CITY OF CAMBRIDGE
BUILDING DIVISION

WILLOW 3E (GR)
ELEVATION 1, 2 & 3

TITLE SHEET
BARLASSINA CONSTRUCTION
CITY OF CAMBRIDGE

MODEL:	
	WILLOW 3E	
	SCALE:	
	3/16" = 1'-0"	
	PROJ. No.	DWG. No.
	21-35	0

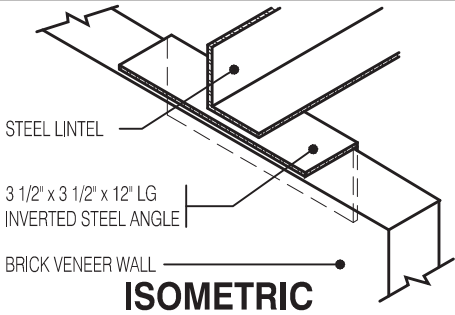
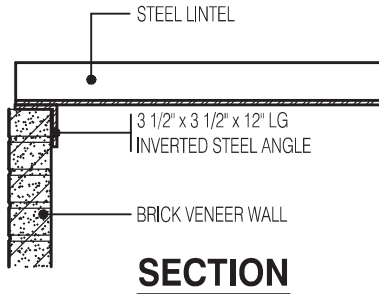
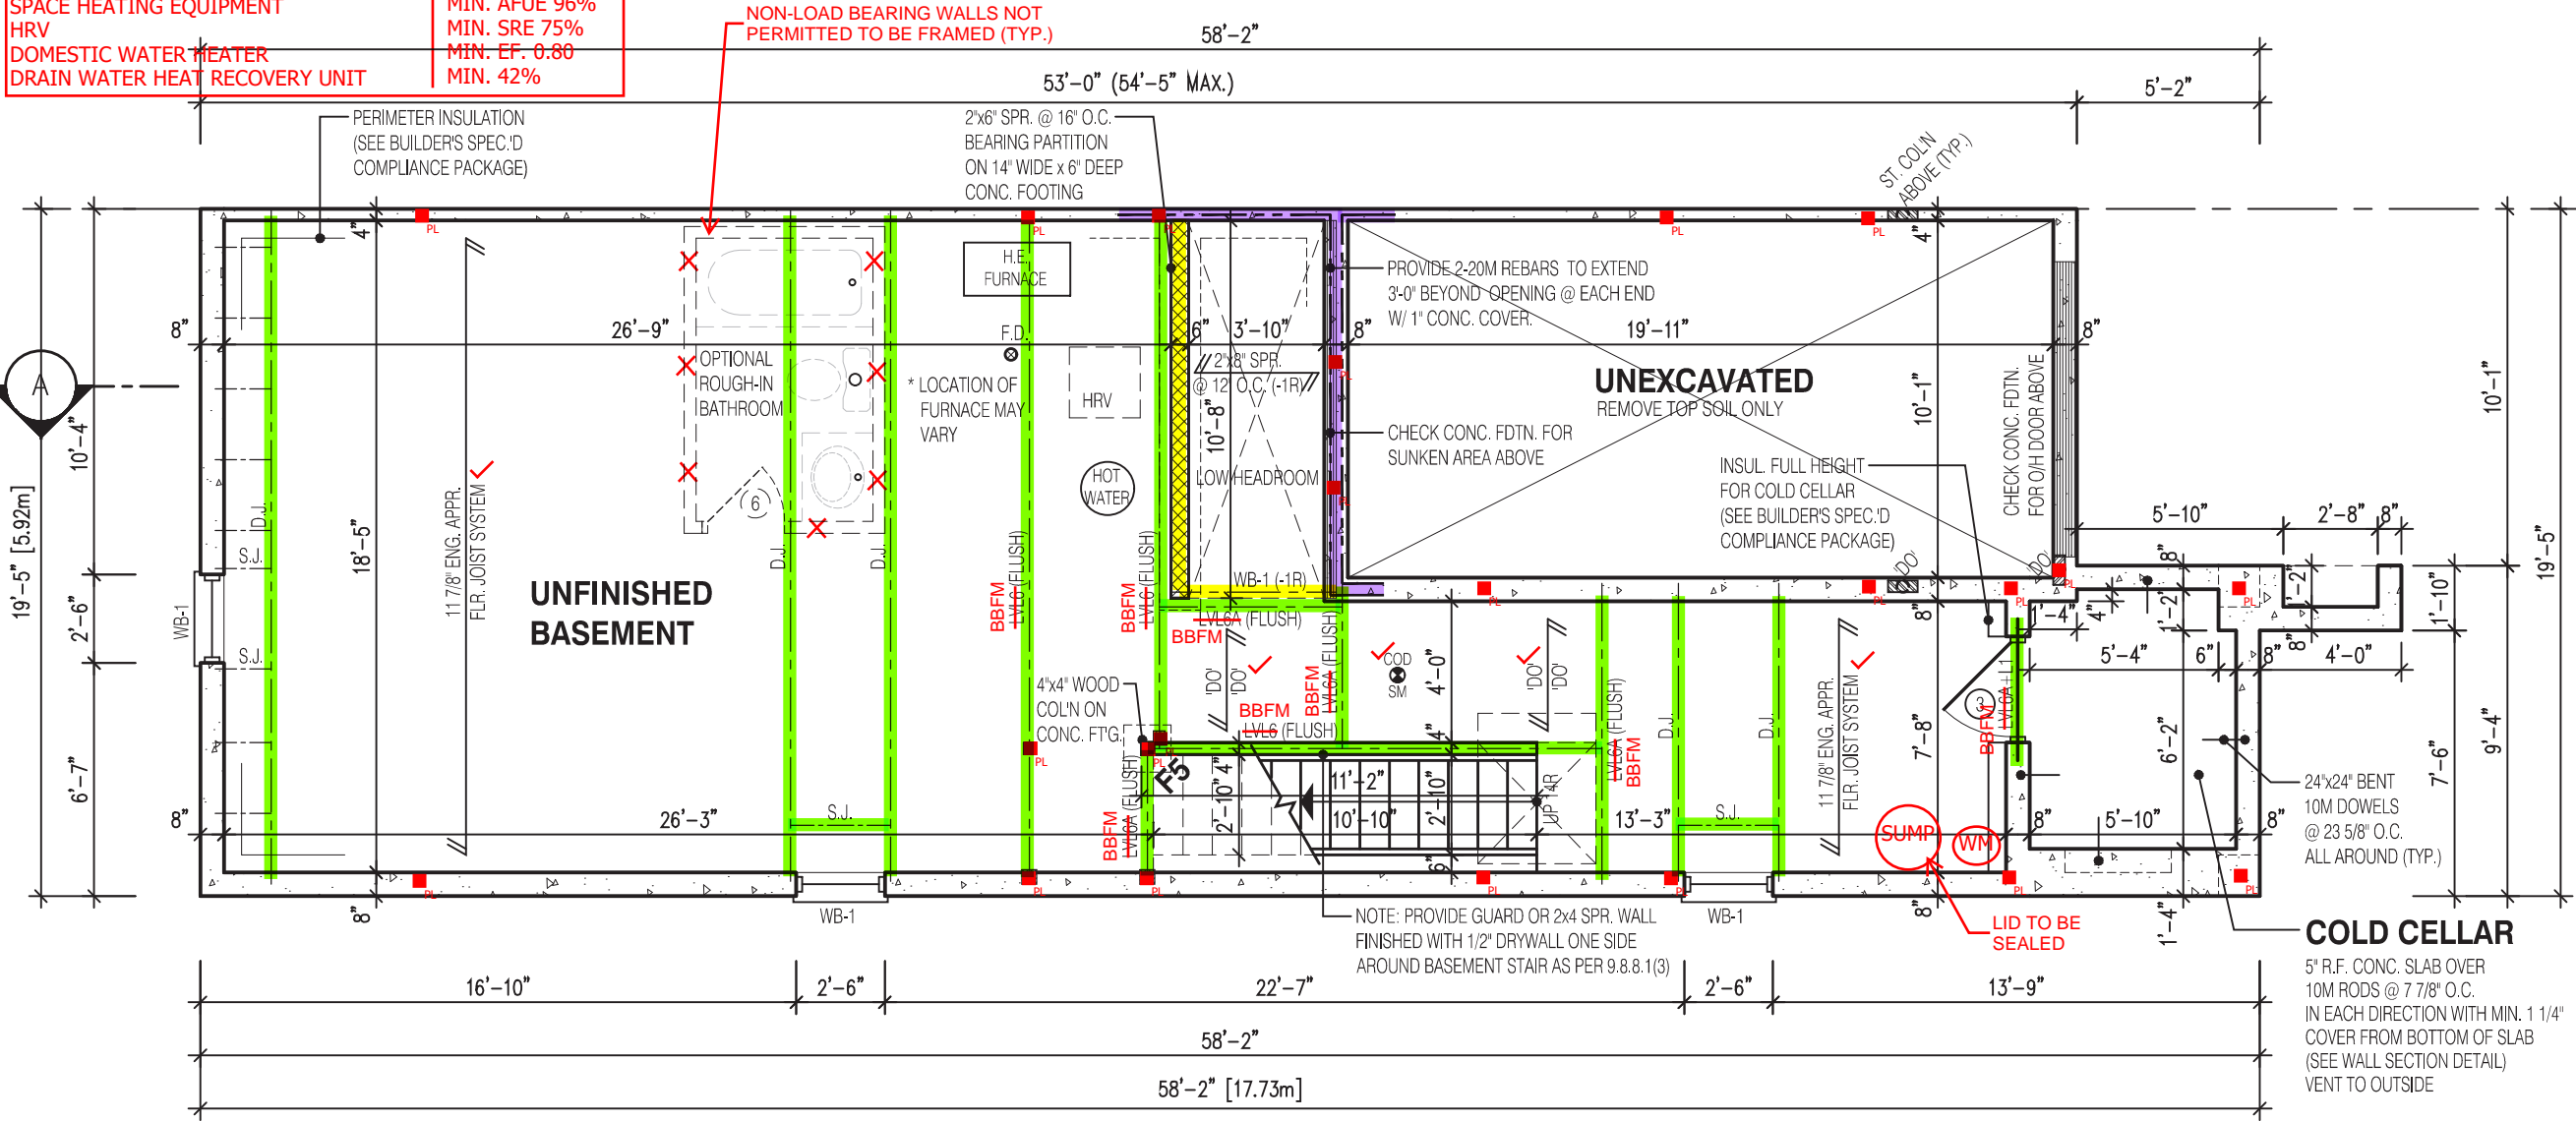
PROVIDE P.ENG APPROVED TRUSS & FLOOR DRAWINGS AND SPECIFICATIONS TO BUILDING INSPECTOR AT FRAMING INSPECTION

INSTALLATION OF FLUSH STEEL BEAMS SHALL CONFORM TO THE REQUIREMENTS OF 9.23.9.2.(3), (4) & (5)

P.ENG SOILS REPORT MAY BE REQ'D TO CONFIRM BEARING CAPACITY OF SOILS. SEE FIELD INSPECTOR

FINAL GRADING CERTIFICATE REQ'D BEFORE FINAL INSPECTION SIGN-OFF

ENERGY PERFORMANCE LABELS FOR ALL GLAZING PRODUCTS IDENTIFYING THE CERTIFIED VALUES SHALL REMAIN ON FOR REVIEW DURING CONSTRUCTION

REINFORCING REQUIRED IN FOUNDATION WALL OR PORCH SLAB SHALL BE REVIEWED PRIOR TO POURING CONCRETE (see Inspector)

A SEPARATE PERMIT IS REQUIRED FOR THE FINISHING OF ALL ROUGHIN PLUMBING FIXTURES

A CARBON MONOXIDE DETECTOR SHALL BE LOCATED ADJACENT TO SLEEPING AREAS

THE ONTARIO BUILDING CODE REQUIRES THAT A SMOKE ALARM BE INSTALLED ON EACH FLOOR LEVEL AND WITHIN EACH SLEEPING ROOM. ALL SMOKE ALARMS SHALL BE INTERCONNECTED. EACH DEVICE SHALL HAVE A VISUAL SIGNALING COMPONENT IN ADDITION TO THE TEMPORAL PATTERN IN CONFORMANCE WITH 18.5.3. OF "LIGHT, COLOUR AND PULSE CHARACTERISTICS" OF NFPA 72

ALL NEW WINDOWS AND SLIDING GLASS DOORS TO COMPLY WITH THE THERMAL REQUIREMENTS OF SB-12. MAX U-1.6, ER-25

FLOORING IN KITCHENS, WASHROOMS, LAUNDRY, AND STORAGE AREAS, SHALL CONSIST OF FELTED-SYNTHETIC-FIBRE FLOOR COVERING, CONCRETE, TILE, OR OTHER FLOORING PROVIDING A SIMILAR WATER RESISTANCE.

MAX. HOT WATER TEMP. SHALL NOT EXCEED 49°C (120°F) EXCEPT FOR DISHWASHERS AND CLOTHES WASHERS

SIDING MATERIALS SHALL CONFORM TO SECTION 9.2.7 OF DIVISION B OR HAVE A CMC OR BMCC APPROVAL, OR A MINISTERS RULING

BASEMENT PLAN EL-3
BARLASSINA CONSTRUCTION
CITY OF CAMBRIDGE

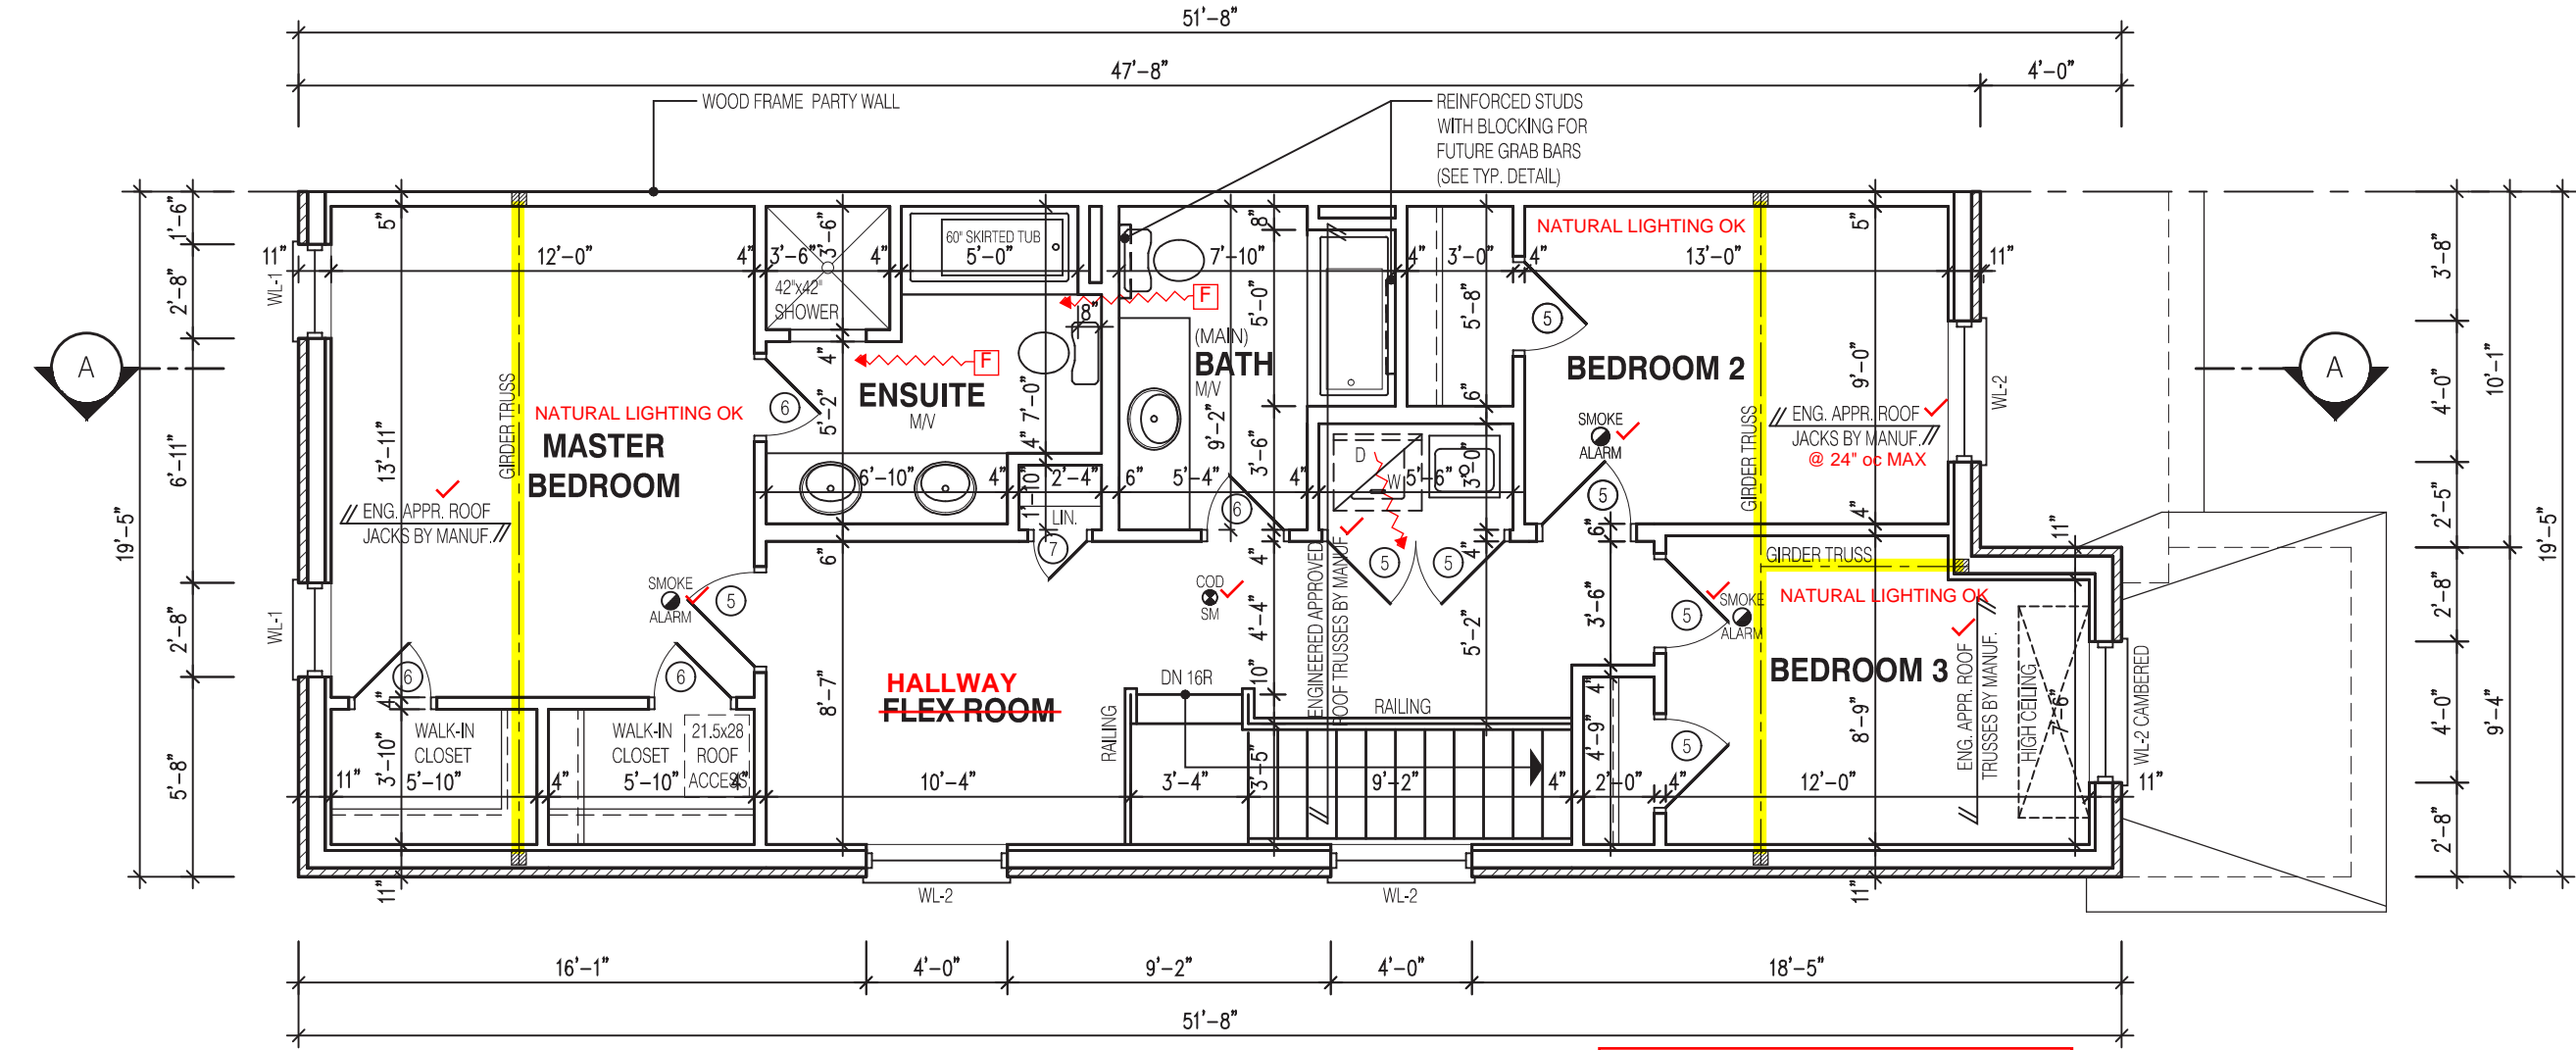
VERIFY WATER METER AND DWHR
UNIT LOCATION WITH INSPECTOR

SPRAY FOAM/RIGID INSULATION TO BE
PROTECTED AS PER 9.10.17.10.(1)

WATER METER TO BE INSTALLED WITHIN 2m
(6'-6") FROM THE POINT THE WATER SERVICE
PIPE MEETS THE BUILDING LINE

REQUIRED CONTINUOUS INSULATION
CANNOT BE INTERRUPTED BY FRAMING
MEMBERS SUCH AS STUDS

SEC. FLOOR PLAN EL-3
BARLASSINA CONSTRUCTION
CITY OF CAMBRIDGE

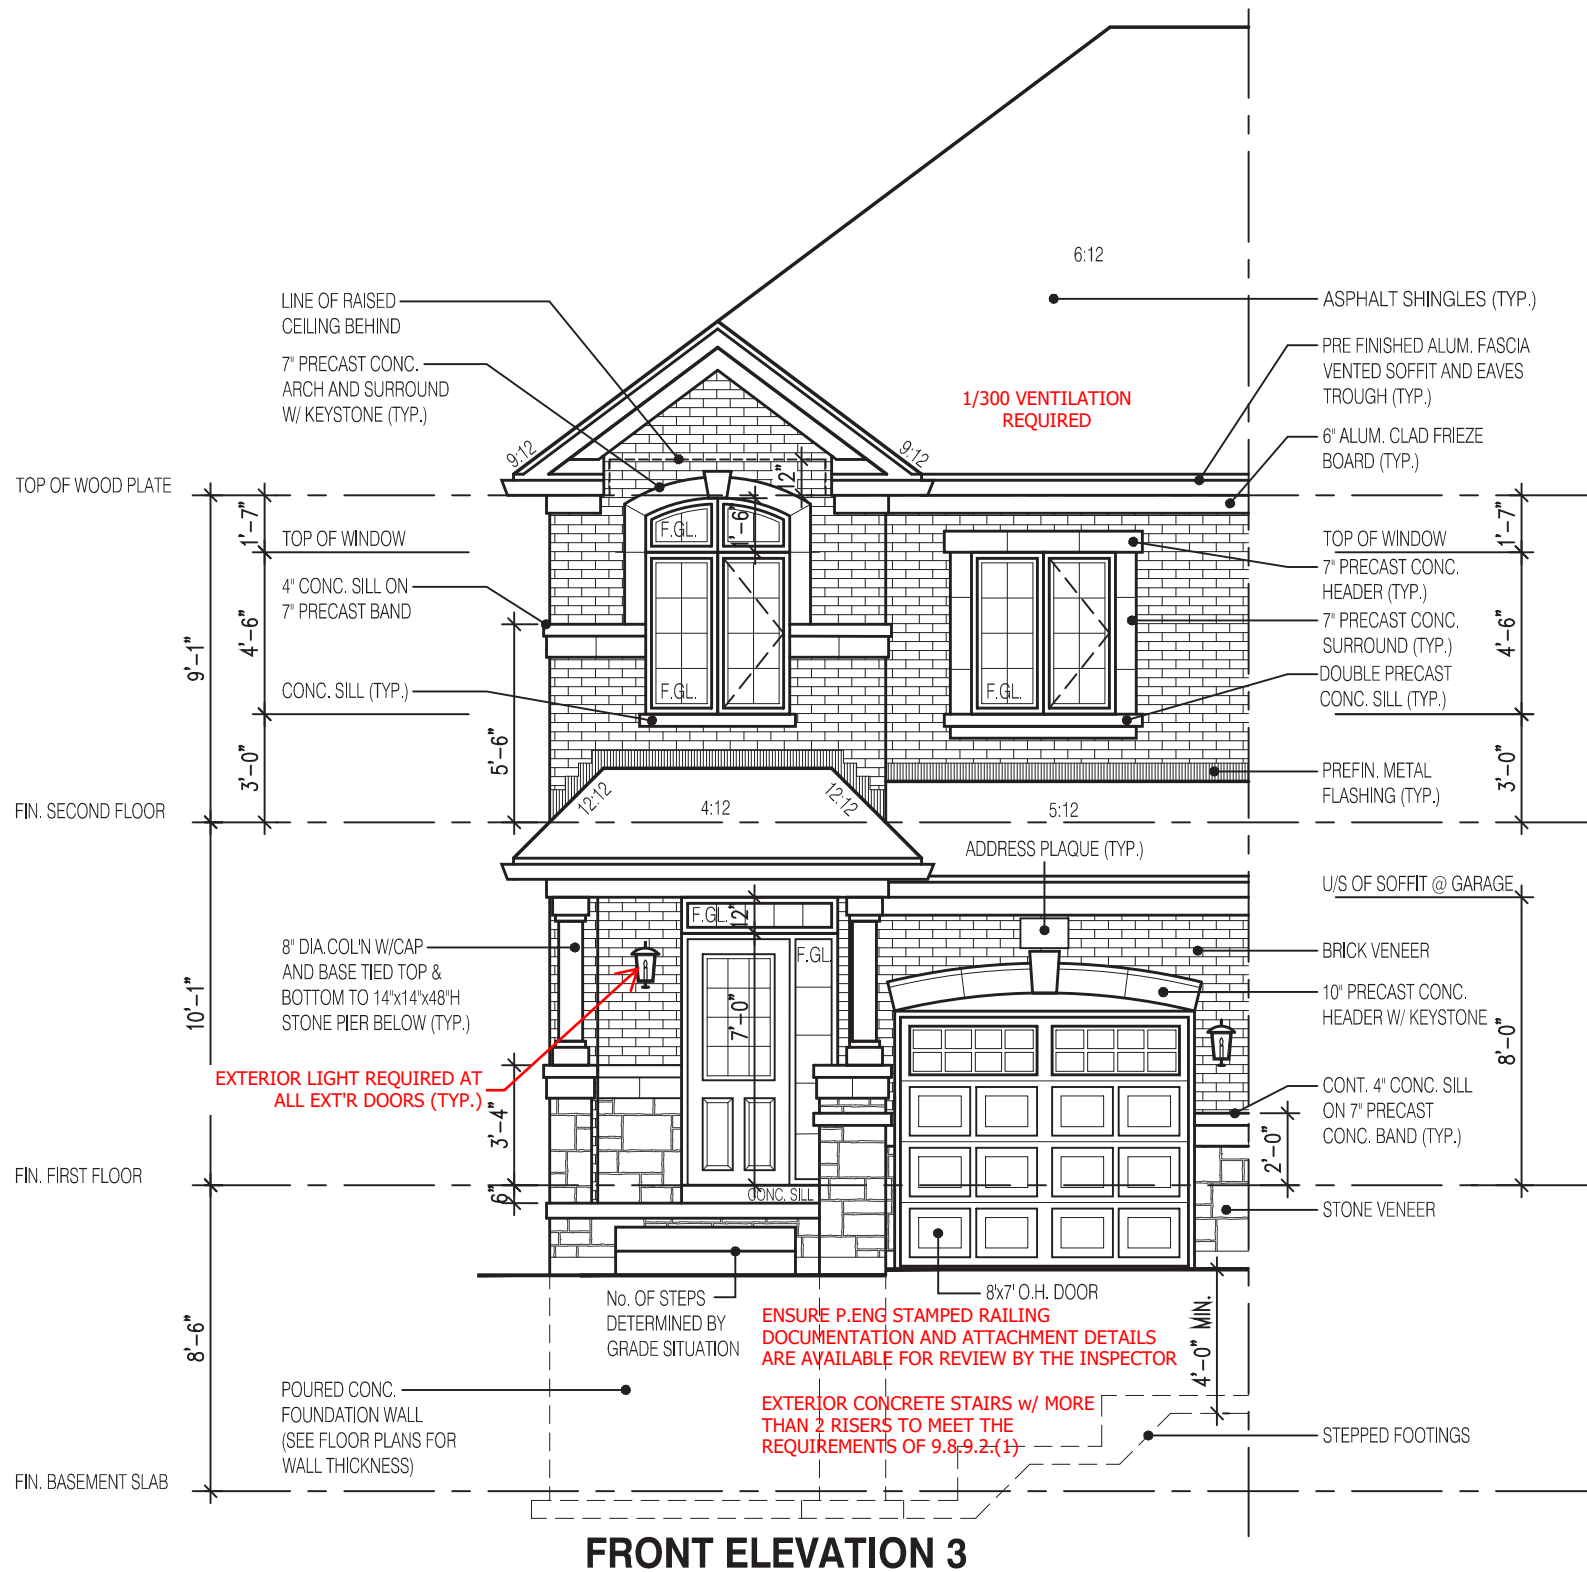
1 WINDOW SHALL PROVIDE AN UNOBSTRUCTED ARE OF 3.8SF w/ NO DIMENSION LESS THAN 15". WINDOW SILL TO BE MAX 39-3/8" ABOVE FINISHED FLOOR.

SIDE ELEVATION 3

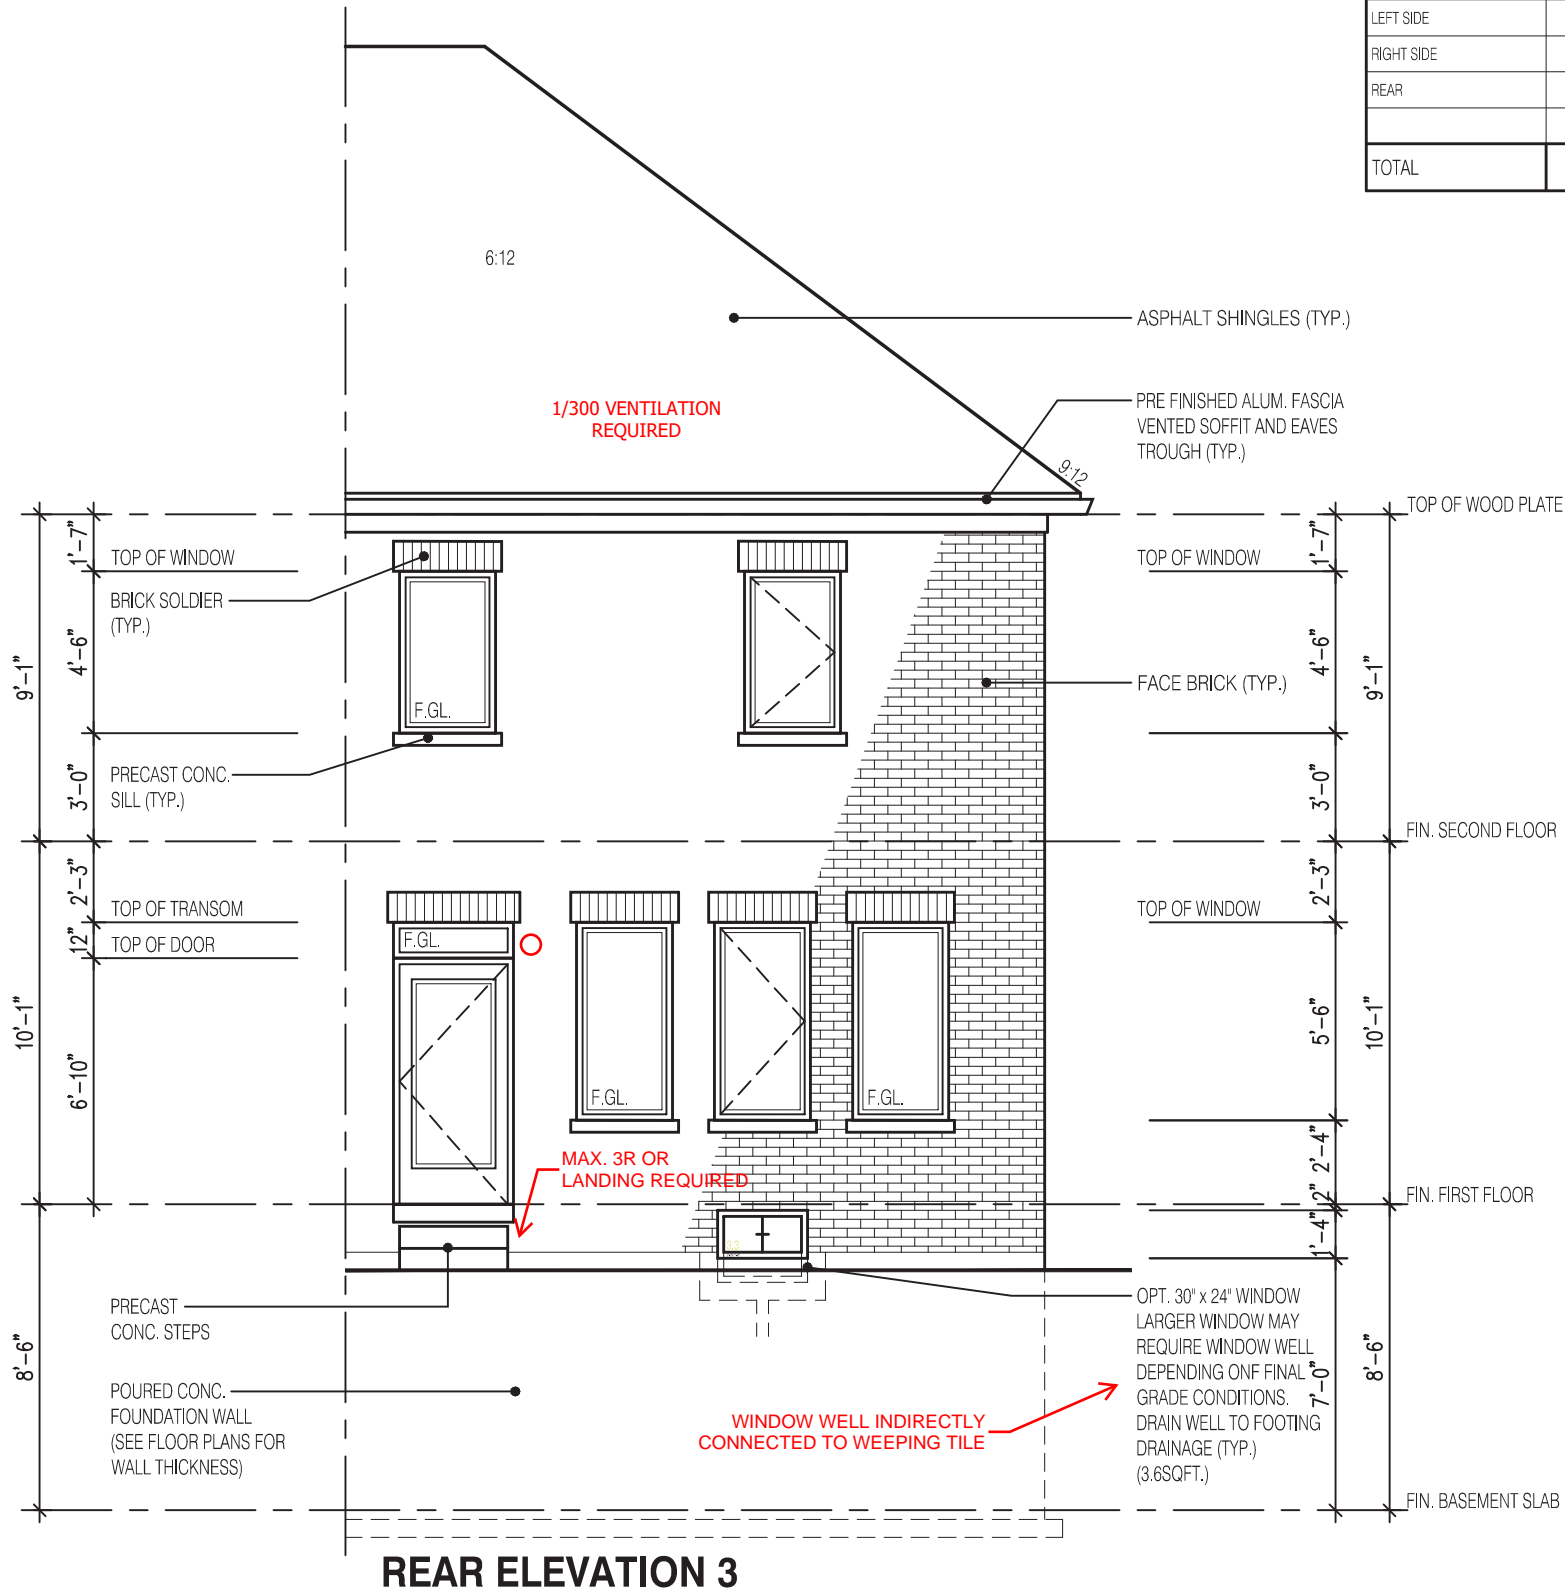
1161 ϕ
81.27 ϕ ✓
~~71.60 ϕ~~
60.91 ✓

~~UNPROTECTED OPENINGS (WITH OPT. 30" x 24" WINDOWS)~~

~~WALL AREA
ALLOWABLE WINDOW AREA @ 7.0%(1.5m SIDEYARD)
ACTUAL WINDOW AREA~~

~~ENLARGED WINDOWS NOT
SHOWN ON THIS ELEVATION~~

~~1161 ϕ
81.27 ϕ
75.00 ϕ~~

WINDOW WELL REQUIRED WHERE LESS
THAN 6" EXPOSED FOUNDATION
PROVIDED UNDER WINDOW
